## Product Change Notification - SYST-18KHMV915

ERRATA - dsPIC33EVXXXGM00X/10X Family Silicon Errata and Data Sheet Clarification

**Description of Change:** Adds silicon issue 48 (I/O).

## dsPIC33EVXXXGM00X/10X Family Silicon Errata and Data Sheet Clarification

FIGURE 1:

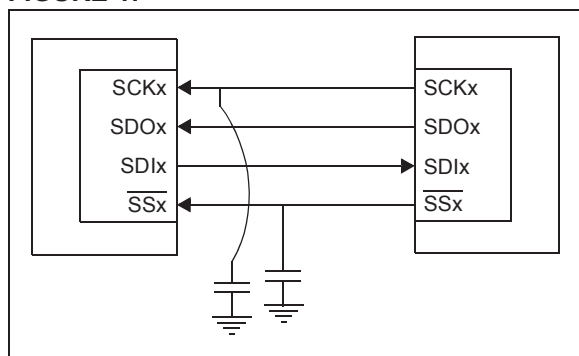
When the SPIx module is configured in SPIx Slave mode (MSTEN bit (SPIxCON1<5>) = 0), the frame slave (FRMEN bit (SPIxCON2<15>) = 1) and the SPIFSD bit (SPIxCON2<14> = 1), in Standard Buffer mode with the Clock Polarity Select bit, CKP = 0, the data is not transmitted in both 8-bit and 16-bit mode, but the data is being received correctly.

Adding a capacitance on the signal, as shown in Figure 1, will help the data to be received properly.

**FIGURE 2: TIMING DIAGRAMS FOR CENTER-ALIGNED AND EDGE-ALIGNED MODES**

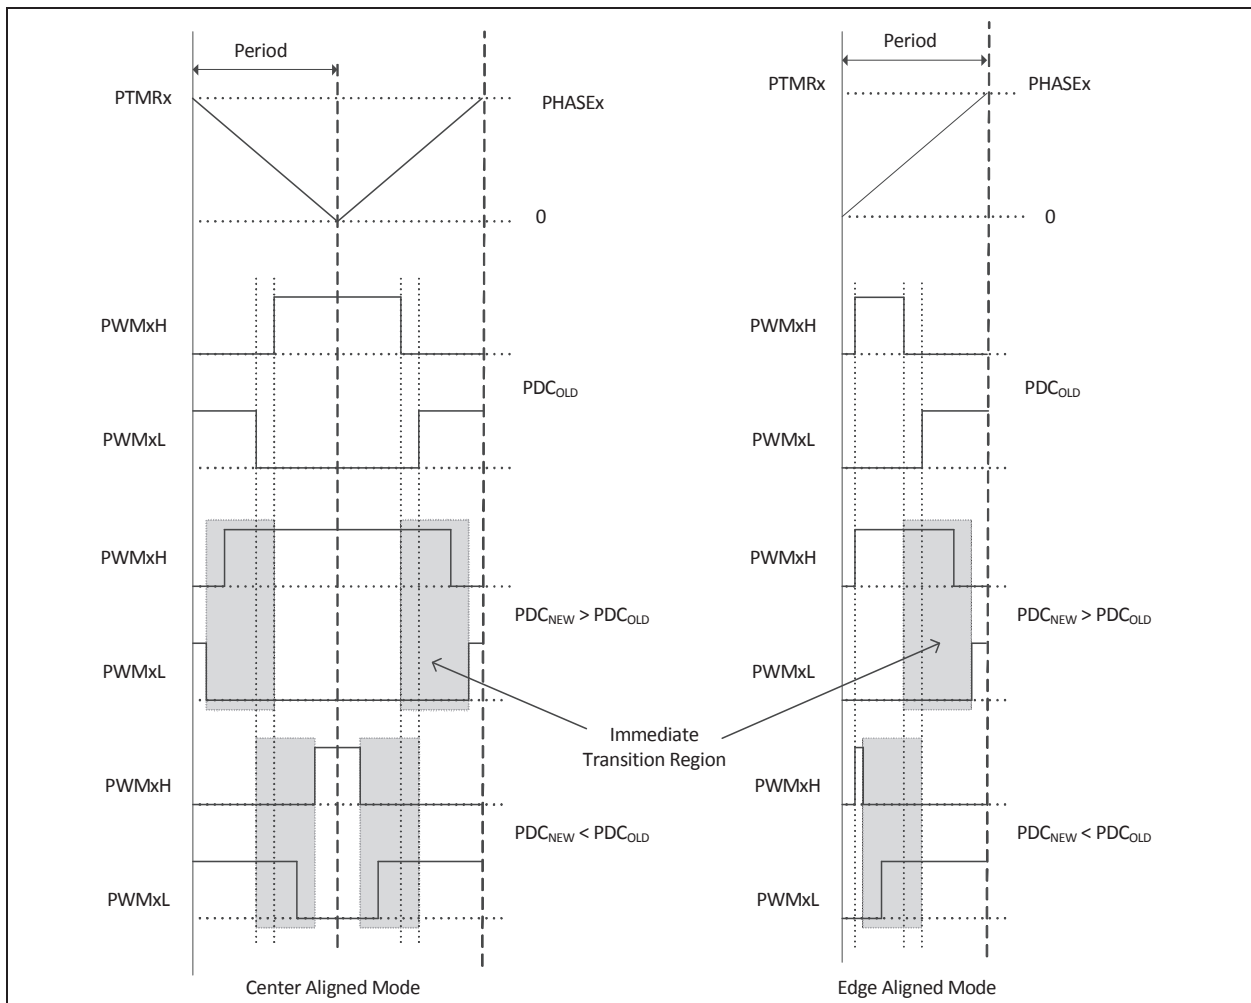
The PWM generator may not assert dead time on the edges of transitions. This has been observed when all of the following conditions are present:

In Figure 2, if the duty cycle write occurred in the shaded box, then PWMxH and PWMxL will make an immediate transition without dead time.

However, in most applications, the duty cycle update timing can be controlled using the TRIGx trigger or Special Event Trigger, such that the above mentioned conditions are avoided altogether.

**FIGURE 3: ILLUSTRATION OF 1 T<sub>osc</sub> GLITCH WHEN PWM OVERRIDE IS TURNED OFF**

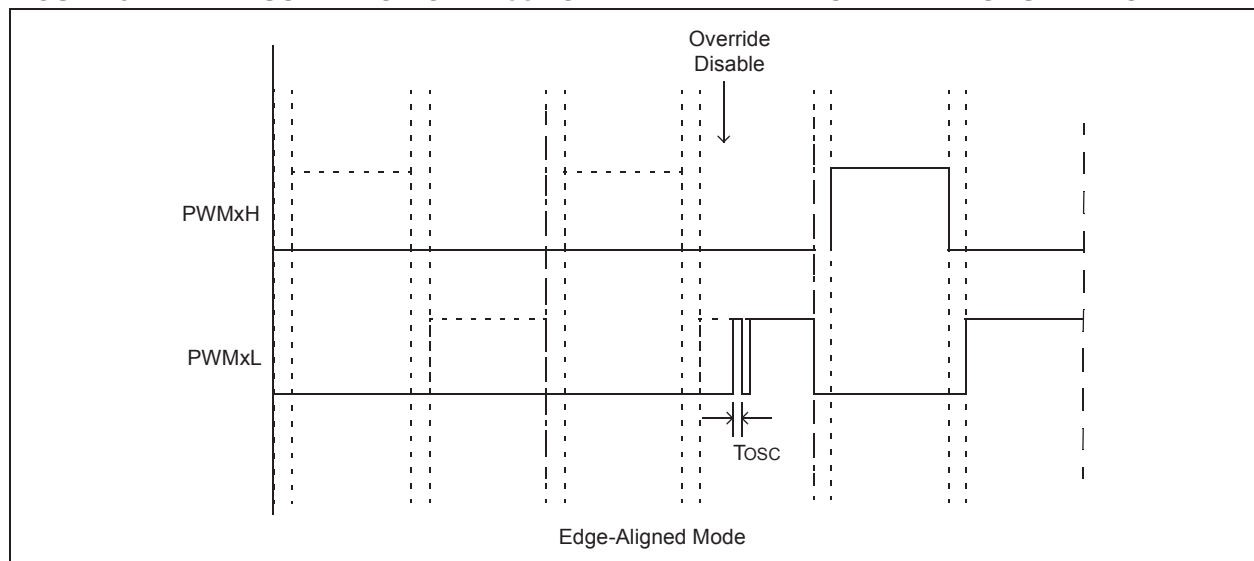
In Complementary mode after the PWM module is enabled (PTEN = 1), if the PWM override is turned off, a one T<sub>osc</sub> glitch will be present on the rising edge of either the PWMxH or PWMxL pins, whichever occurs first, as shown in Figure 3.

The glitch will be present on PWMxH/PWMxL every time the override state is changed from override enabled to override disabled. The width of this glitch is equal to one T<sub>osc</sub> when PCLKDIV<2:0> (PTCON2<2:0>) = 000. Increasing the PWMx input clock prescaler setting will increase the width of the glitch accordingly.

FIGURE 4:

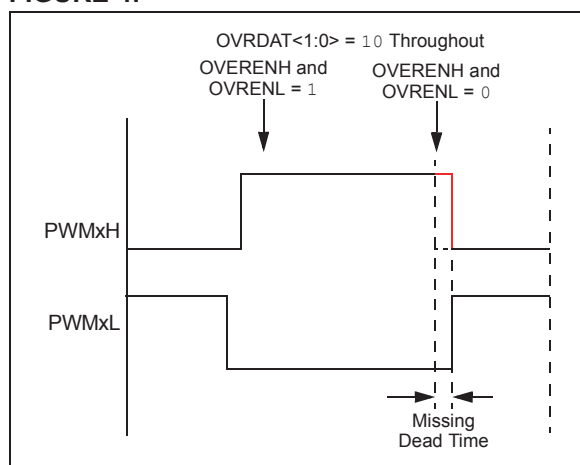
In Complementary Output mode, the expected dead time between transitions of the PWMxH and PWMxL outputs may not be asserted when the following occurs:

- Output override synchronization is configured to occur on the CPU clock boundary (IOCONx<0> = 0);
- Both PWMxH and PWMxL overrides are enabled prior to the event (OVRENH and OVRENL are both '1'), and
- Both overrides are disabled (OVRENH and OVRENL are both '0') at the instant the dead time should be asserted (Figure 4). This has been observed in both Center-Aligned and Edge-Aligned modes.

FIGURE 5:

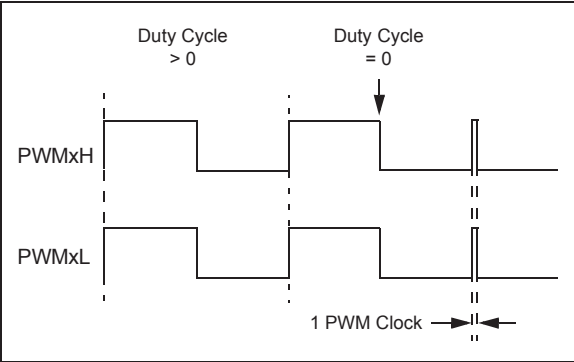
In the Redundant Output mode (IOCONx<11:10> = 10) and Push-Pull Output mode (IOCONx<11:10> = 01) with Immediate Update disabled (PWMCONx<0> = 0), when the Duty Cycle register is updated from a non-zero value to zero, a glitch pulse of a width equal to one PWM clock will appear at the next PWM period boundary, as shown in Figure 5, for the Redundant Output mode. Here, the Duty Cycle register refers to the PDCx register if PWMCONx<8> = 0 or the MDC register if PWMCONx<8> = 1.

If the application requires a zero duty cycle output, there are two possible work around methods:

1. Use the PWM override feature to override the PWM output to a low state instead of writing to the Duty Cycle register. In order to switch back to a non-zero duty cycle output, turn off the PWM override. The override-on and override-off events must be timed close to the PWM period boundary if the IOCONx register has been configured with IOCON<0> = 0 (i.e., output overrides via the OVDDAT<1:0> bits occur on the next CPU clock boundary).

2. Enable the Immediate Update (PWMCONx<0> = 1) while configuring the PWM module, i.e., before enabling the PWM module (PTCON<15> = 1). With Immediate Update enabled, writes to the Duty Cycle register can have an immediate effect on the PWM output. Hence, duty cycle write operations must be timed close to the PWM period boundary in order to avoid distortions in the PWM output.

**FIGURE 7: SIMPLIFIED BEHAVIOR**

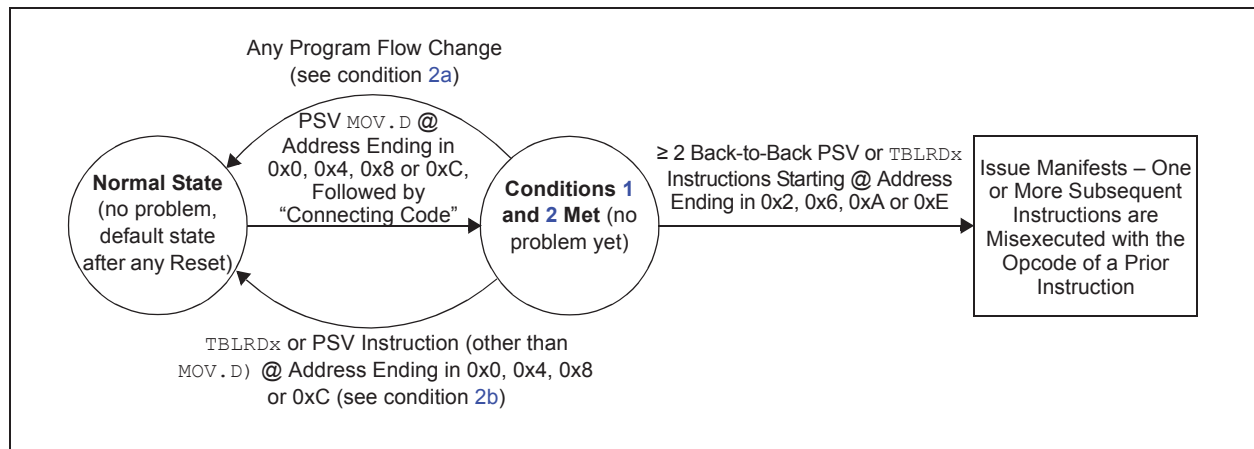
3.	≥ 2 back-to-back PSV or <code>TBLRDx</code> instructions are executed (following the code of condition 2), where the first of the back-to-back instructions is located at an address ending in 0x2, 0x6, 0xA or 0xE.

[Figure 7](#) provides an example of the effective behavior.

1. All instances of PSV `MOV.D` can be replaced with two PSV `MOV` instructions instead. Non-PSV `MOV.D` instructions acting on RAM/SFRs do not need to be modified; or
2. If not already present, a program flow change instruction (such as `BRA $+2`) can be inserted above back-to-back data Flash read sequences; or
3. Back-to-back data Flash read instruction sequences can be broken up by inserting a non-Flash read instruction (such as a `NOP`), in between the Flash read instructions; or
4. The alignment of the code can be shifted to avoid the required opcode location addresses.

C code built with MPLAB® XC16 Compiler Version 1.32, or later, implements the work around by default. However, if the application uses Assembly language routines, these should be manually modified to implement the work around. Additionally, if precompiled libraries are used, these should be built with XC16 Version 1.32 or later. For additional information, please visit: [www.microchip.com/erratum\\_psrds\\_psrds](http://www.microchip.com/erratum_psrds_psrds)
